# **Puente Hills Landfill Park Master Plan**

## **Final Program Environmental Impact Report**

**September 2016**

*Figure 3.2-16 View from Rose Hills Looking Northeast from the Garden of Commemoration to Nike Hill*

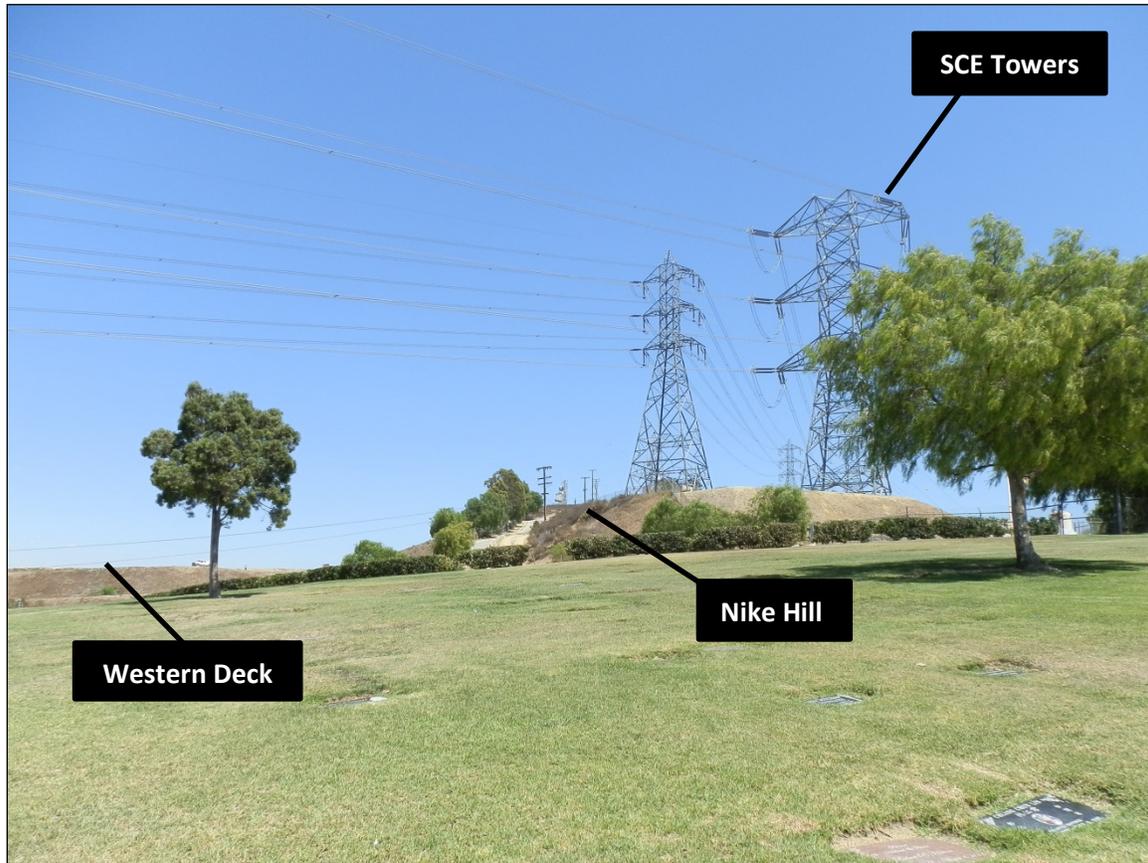
Views of the west and partial views of the north face of Nike Hill would only be available to Rose Hills' visitors near the northern property fence at the Garden of Commemoration II Lawn looking northeast towards Nike Hill (Figure 3.2-17). As seen in Figure 3.2-17, views of Nike Hill contain vegetated slopes, radio towers, power poles, a water tank, a paved road, and trees. The Proposed Project would add a scenic overlook, trail lift tower, mini café, staff offices,

From Rose Hills, visitors would only have views of the western edge of the Western Deck, as shown on Figure 3.2-17. In this area the Proposed Project would develop a running loop and a bike skills area, along with added revegetation of these largely barren areas. These features are not structures and would be partially blocked from view by trees and hedges to be planted throughout the Western Deck as depicted in Figure 2-5. With the addition of such vegetation and low level park structures, changes in view would likely be considered as beneficial by many viewers.

**Figure 3.11-2 Operational Noise Contours**

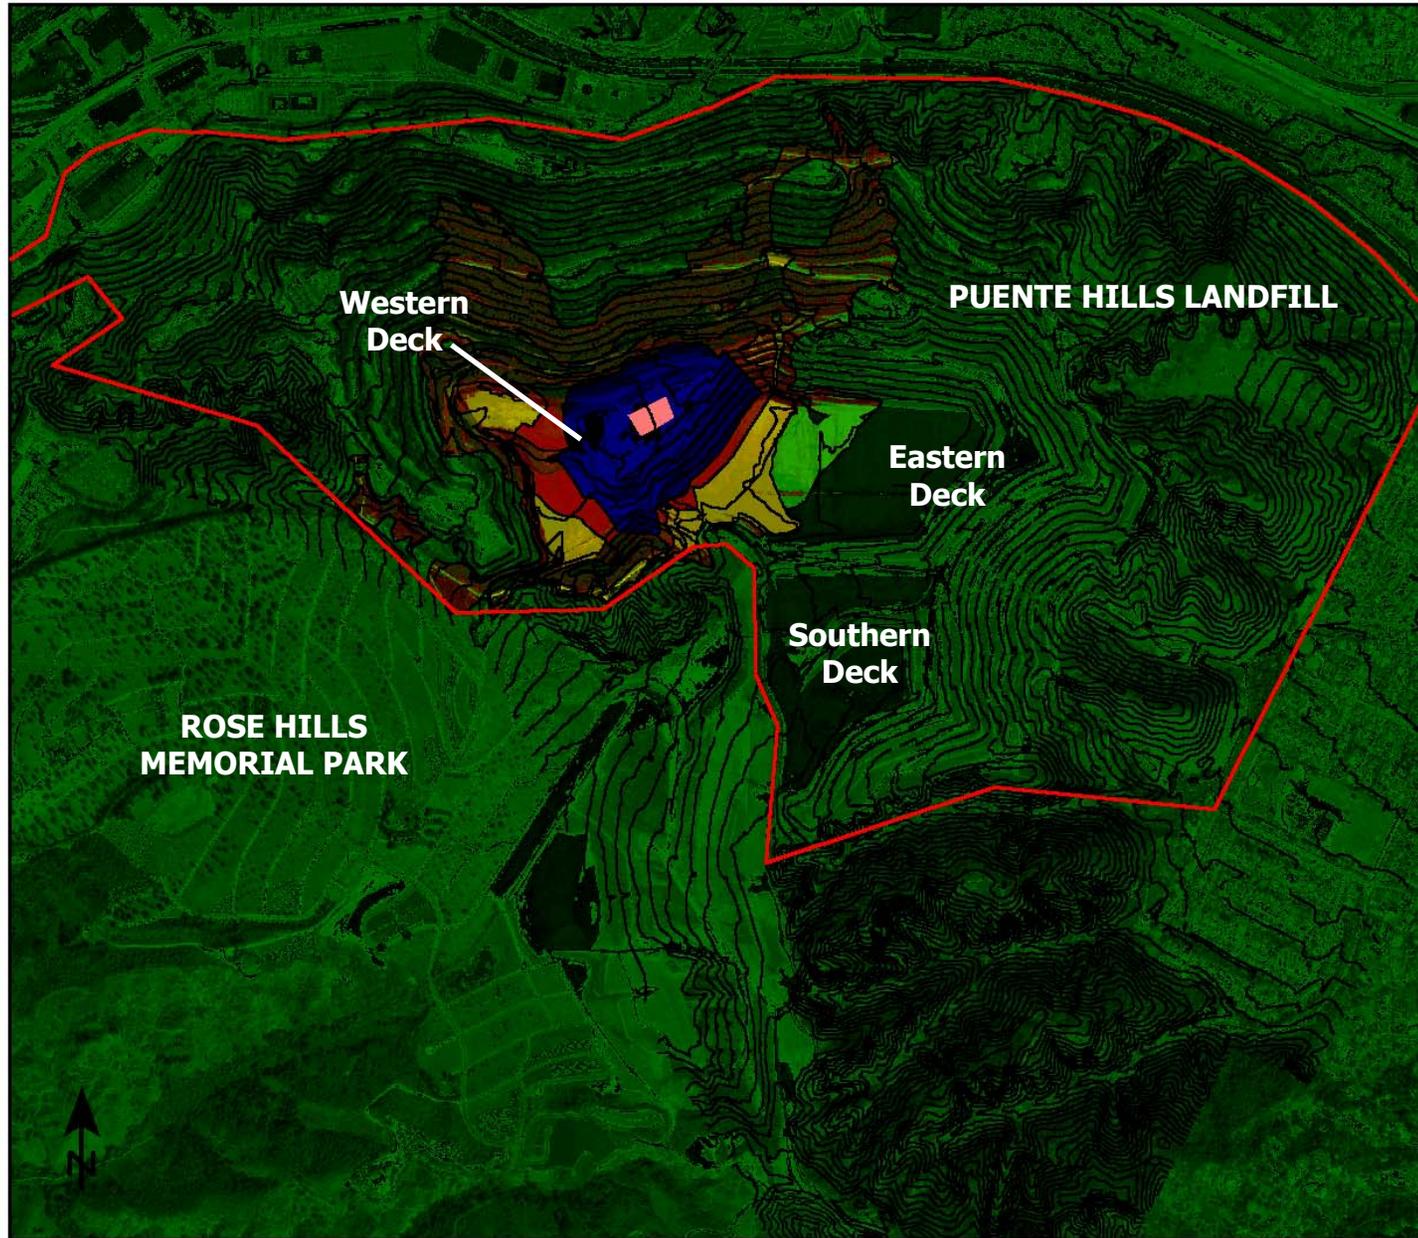
With regard to operational noise associated with the Proposed Project, the County does not provide specific impact thresholds for cemeteries; however, Figure 2 within Appendix C of the California Office of Planning and Research's (OPR) General Plan Guidelines (2003) provides acceptable ranges for noise levels for several types of land uses, including cemeteries. Table 3.11-4 on pages 3.11-10 and 3.11-11 of the Draft PEIR was intended to reflect Figure 2 in Appendix C of OPR's General Plan Guidelines; however the table in the Draft PEIR is inadvertently incorrect. Accordingly, Table 3.11-4 has been replaced with the correct acceptable ranges for noise levels per land use (refer to the Section 4.0 of the Final PEIR for the corrected Table 3.11-4).

29. Table 3.11-4 on page 3.11-10 of the Draft PEIR has been replaced with the correct acceptable ranges for noise levels per land use.
30. Figure 3.11-2 has been added to the impact discussion on page 3.11-24 of the Draft PEIR (Noise Impacts to Off-site Receptors Due to On-site Operational Noise).
